| 8802-3/802.3 REVISION REQUEST 1117 |

DATE: 31st Oct, 2003  
NAME: Dave Dwelley  
COMPANY/AFFILIATION: Linear Technology  
E-MAIL: ddwelley@linear.com

REQUESTED REVISION:  
STANDARD: IEEE Std. 802.3af-2003  
CLAUSE NUMBER: 33.2.3.7  
CLAUSE TITLE: State Diagrams

Figure 33-6—PSE state diagram

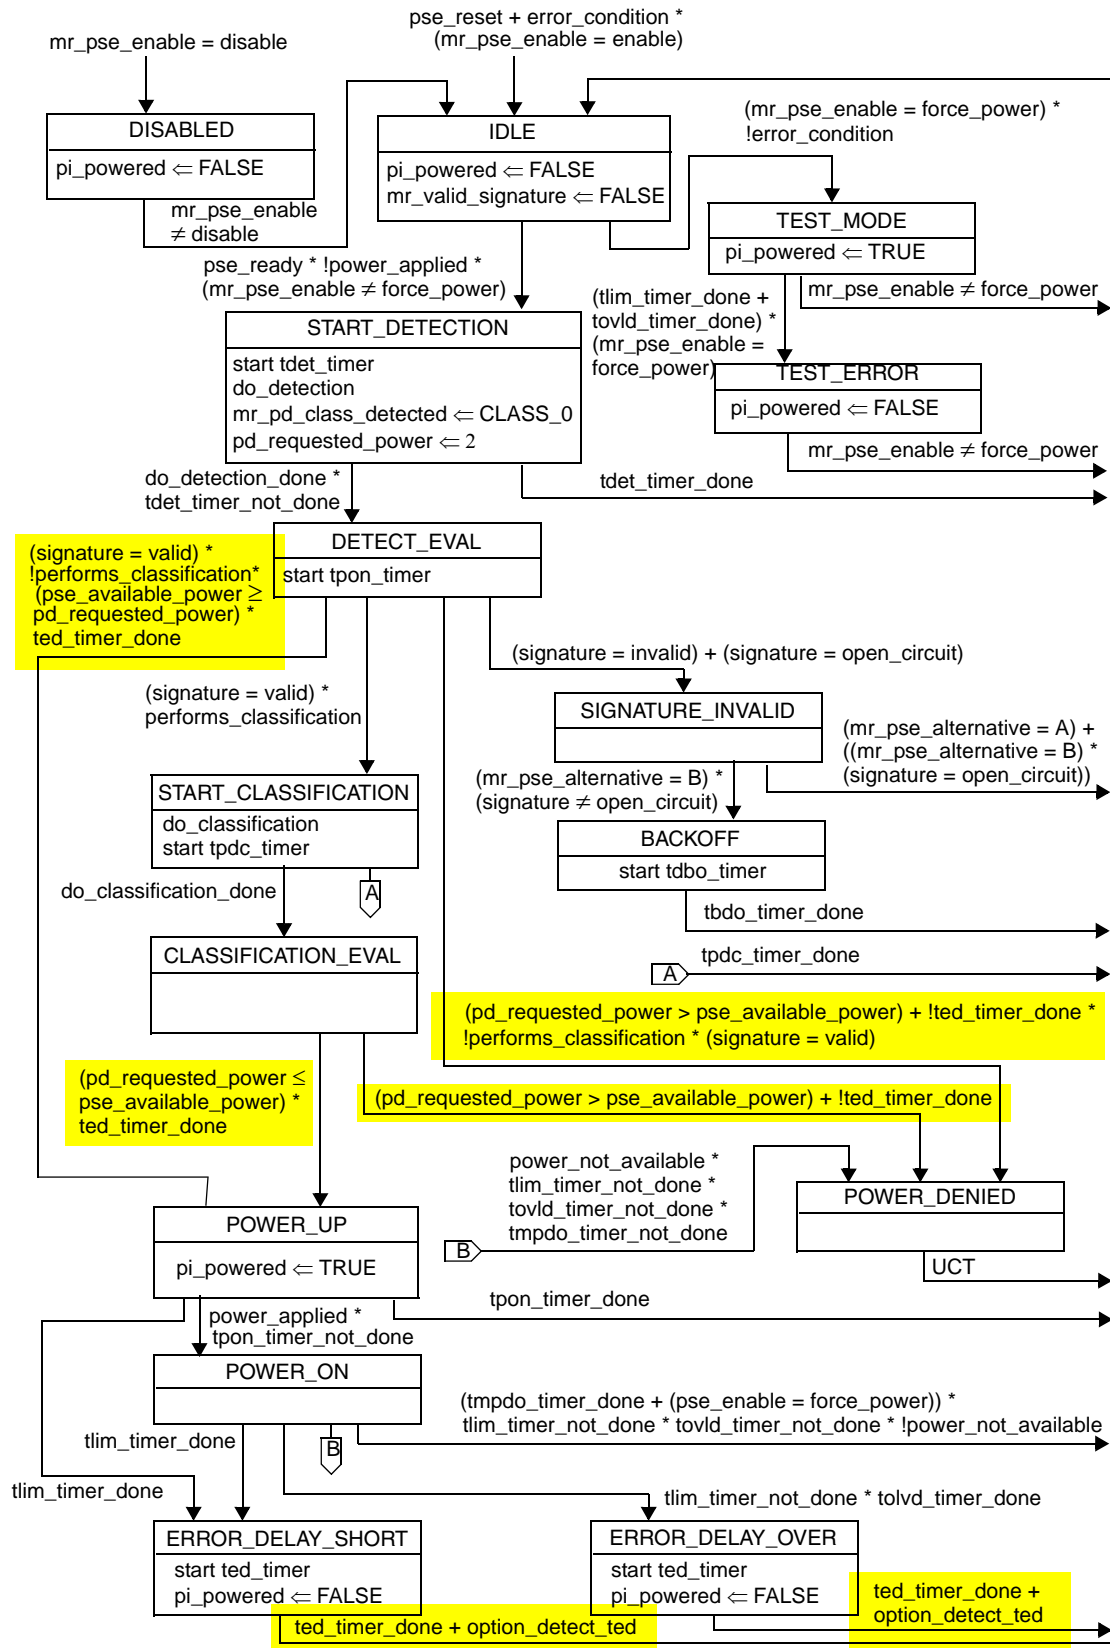
Change state machine per attached markup.

The current state machine prevents detection during a TED\_TIMER interval, which is a valid mode of operation (per my comment 28 against 802.3af-D4.1). This change allows this alternate mode of operation without breaking current hardware.

33.2.3.7 State diagrams (replace figure 33-6 with the following - changes highlighted)
